Proof of Evidence on Behalf of East Sussex County Council

Bird in Eye south, Framfield Road, Uckfield

Planning Application Ref: WD/2021/2198/MAO
PINS Ref No: APP/C1435/W/22/3307820

Figure 2.3.1 Approximate priority junction provision on single carriageway roads based on flows only

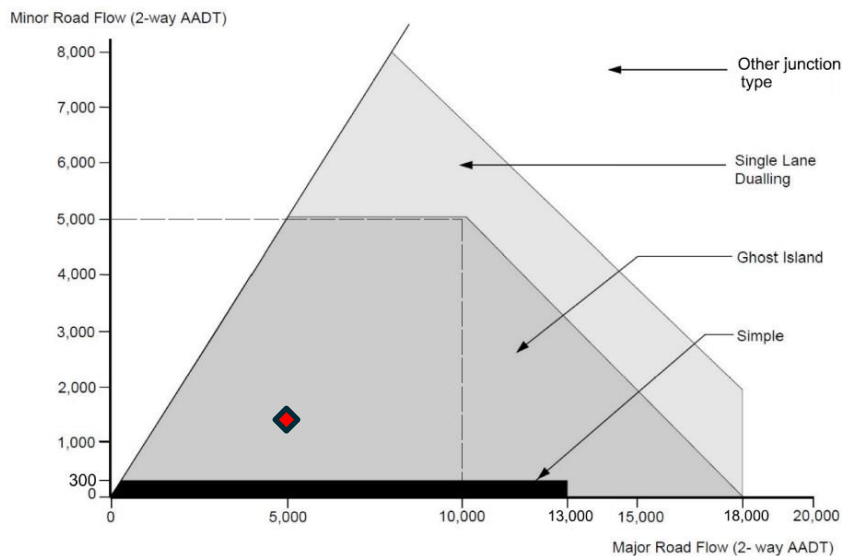
- 2.10 For the mix of major and minor road flows set out in para 2.7 above, Figure 2.3.1 of DMRB technical standard CD123 'Geometric design of at-grade priority and signal-controlled junctions' (**CDI.7**) places this combination of major and minor road flows firmly in the area where a ghost island arrangement is the most likely appropriate junction provision.

Figure 5.6.2N2 Corner radius tapers at priority junctions without diverge tapers or auxiliary lanes

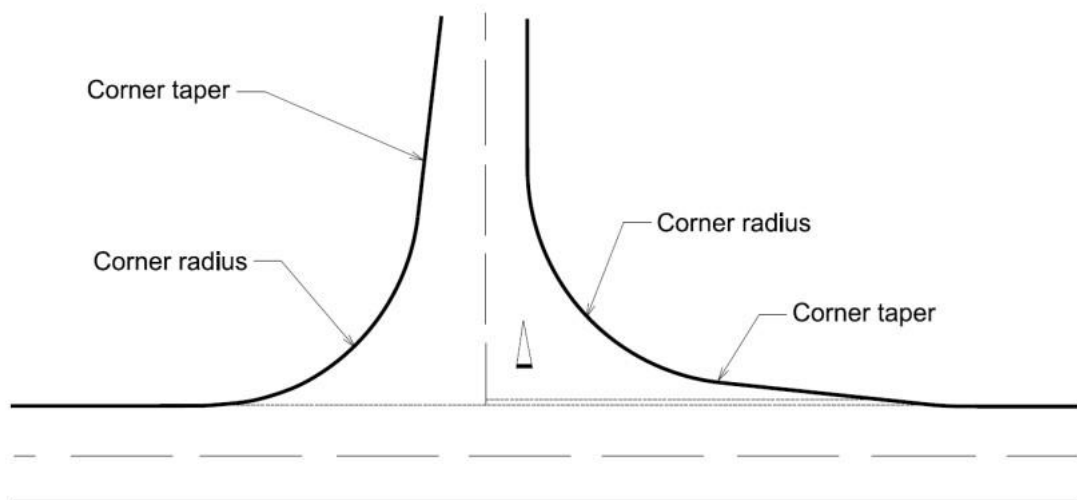
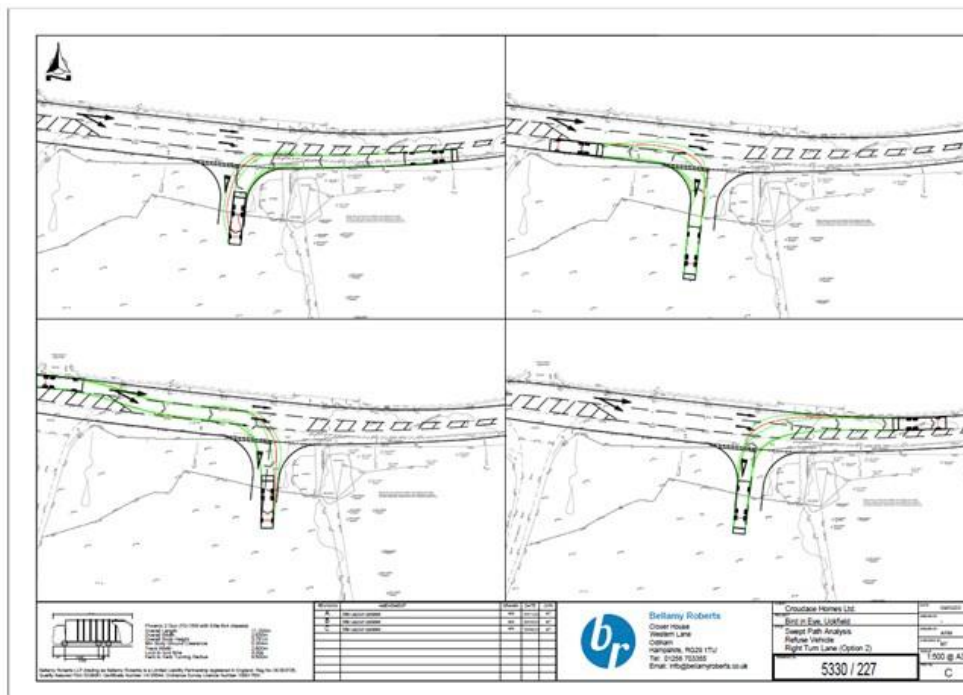
- 2.20 Whether the simpler 5.6.1 design or the more complex 5.6.2/3 design is the more relevant depends on whether there is a need to provide for the 'design vehicle', which is defined as the largest vehicle expected to use the junction in sufficient numbers. Para 5.2 of CD123 provides guidance on the appropriate design choice thus:

- 2.21 If, on that basis, it was determined that there is no need to provide for the design vehicle then CD123 para 5.6.1 would apply. As the site main access junction location is, and would remain, much more rural than urban in character that would require the simple 10m corner radius applicable to rural areas, not the 8m corner radius shown in all submitted designs including 021 Rev K. It is worth noting that if the location was considered to be urban, which ESCC do not consider to be the case, CD123 para 5.6.1 would require a simple 6m corner radius. It is not clear why all submitted designs include the 8m radii proposed.

- 2.22 If, instead, it was determined that the volume of worst-case design vehicles exceeded a "*very small percentage of the total number of vehicles that will use the junction*" paras 5.6.2/3 would apply requiring 15m corner radii together with corner tapers in a rural location such as this, or 10m plus tapers in an urban location.
